**PROPOSED SOCIAL WELFARE FACILITY (RESIDENTIAL CARE HOME FOR PERSONS WITH DISABILITIES) IN “VILLAGE TYPE DEVELOPMENT” ZONE ON
APPROVED NAM SANG WAI OUTLINE ZONING PLAN NO. S/YL-NSW/10 AT LOTS 3669 S.A RP (PART), 3669 S.B RP (PART), 3670 RP (PART) AND
ADJOINING GOVERNMENT LAND IN D.D.104, NAM SANG WAI, YUEN LONG**

(Planning Application No. A/YL-NSW/348)

Response-to-Comment Table

**PROPOSED TERMINAL MANHOLE AND
CONNECTION**

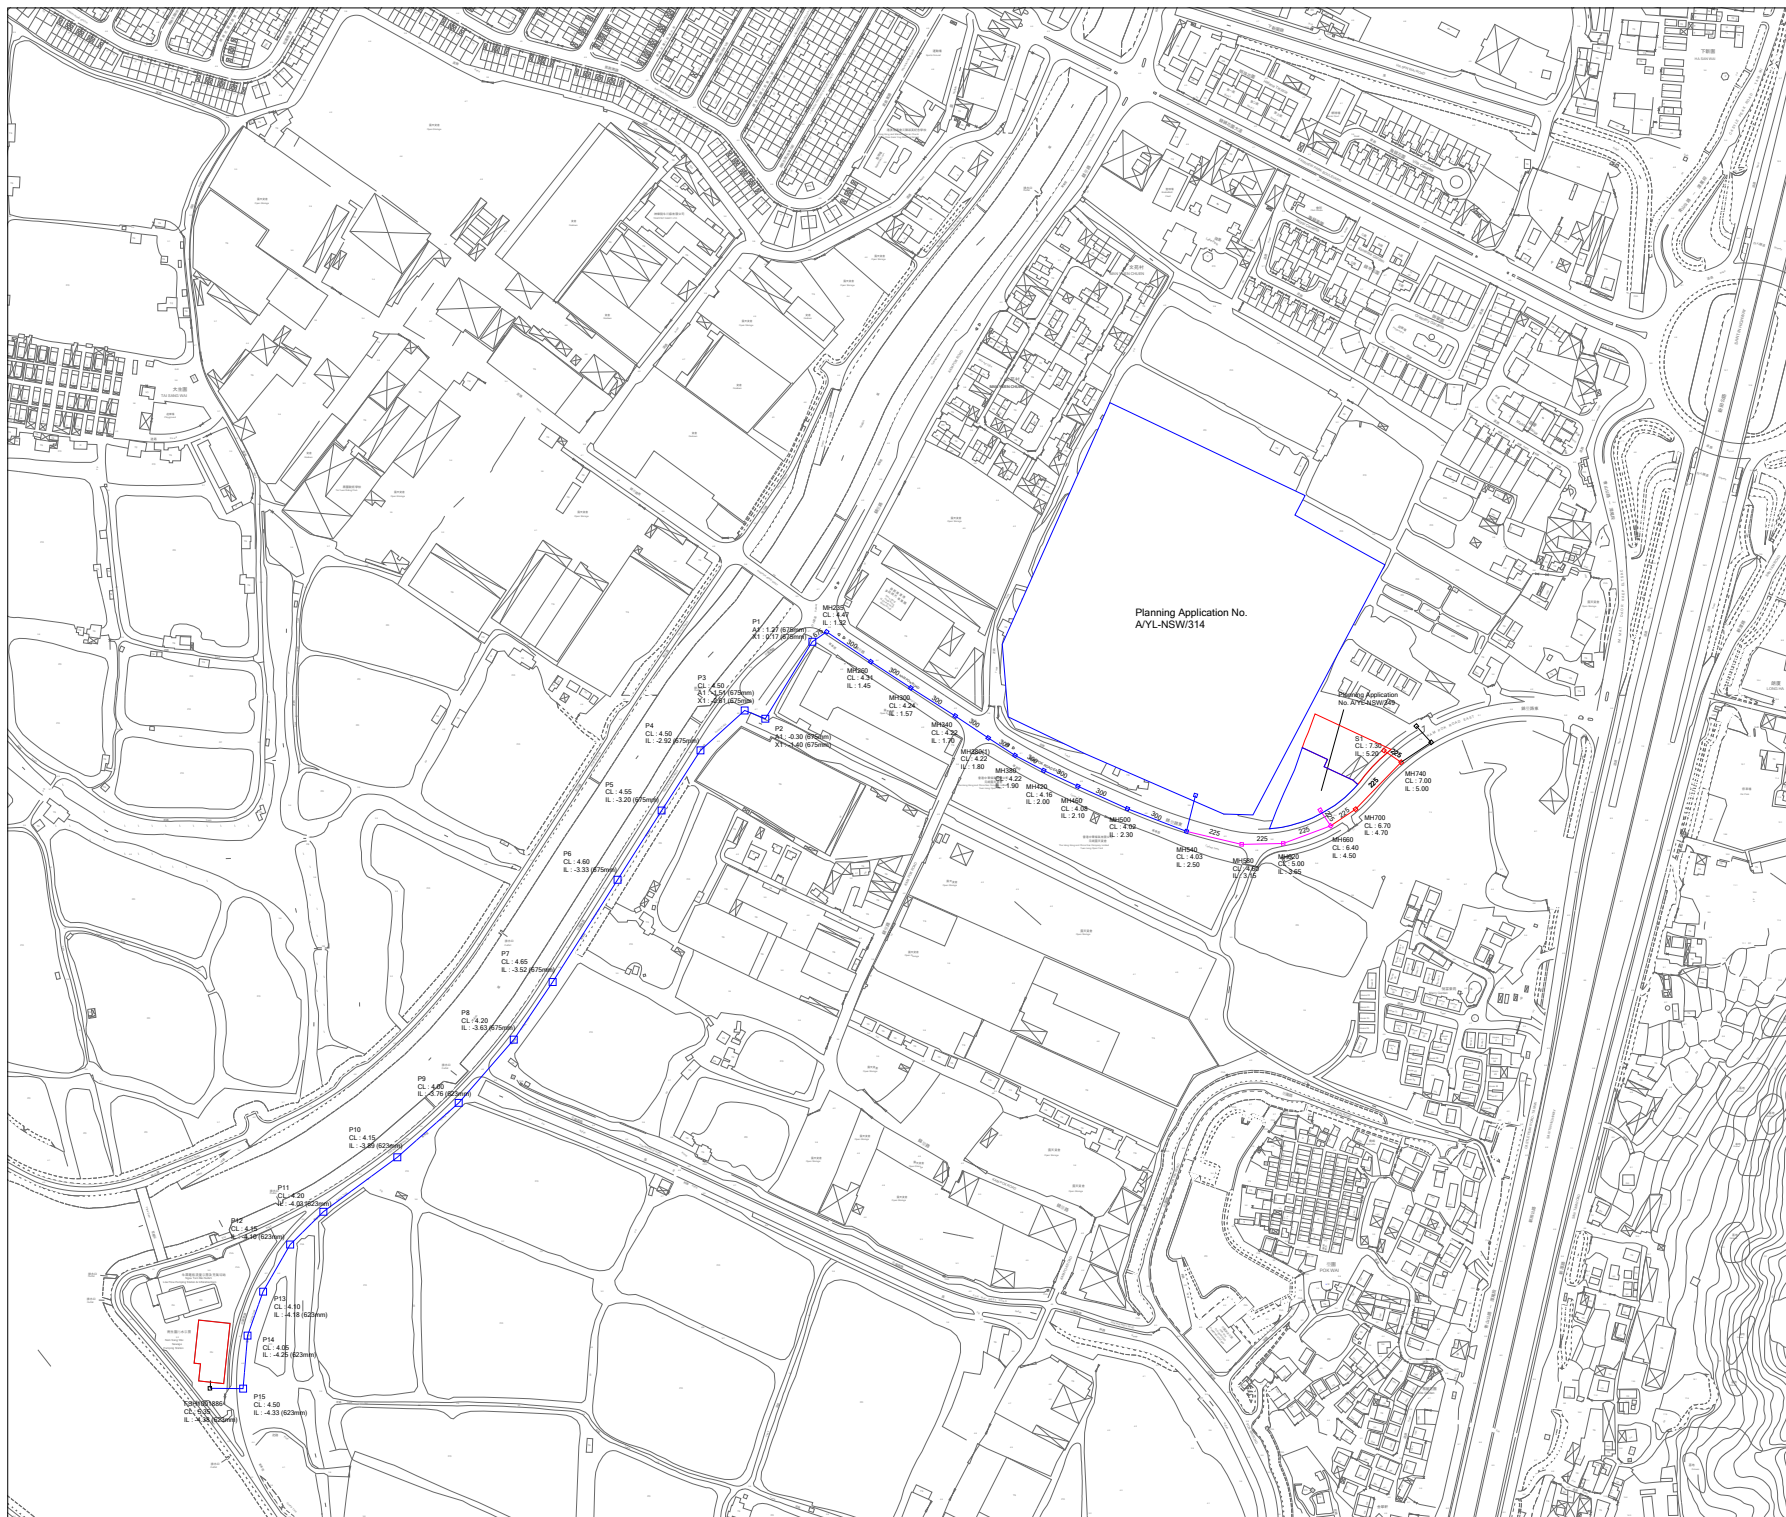
and adopt a conservative approach for the pipe diameter in the hydraulic assessment.	
4. Section 2.4.1 – a. Please revise as “New terminal manhole (namely S1) and manholes MH700 and MH740 will be constructed to collect..” b. Please revise “connect to the communal sewer” as “connect to MH660”.	The Section is revised accordingly.

- 2.4.1. New terminal manhole (namely S1) and manholes MH700 and MH740 will be constructed to collect the sewage generated from the Proposed Development and connect to manhole MH660 via a new 225mm diameter sewer pipe. The location of the proposed connection are shown in **Figure 3**. The cover level of proposed terminal manhole should be higher than that of the downstream public manhole(s). The proposed new terminal manhole and 225mm sewer pipe within site boundary will be implemented and maintained by the Project Proponent, other proposed manhole and sewer outside site boundary will become a public sewage system serving multiple users and will be handed over to government for future maintenance. The capacity
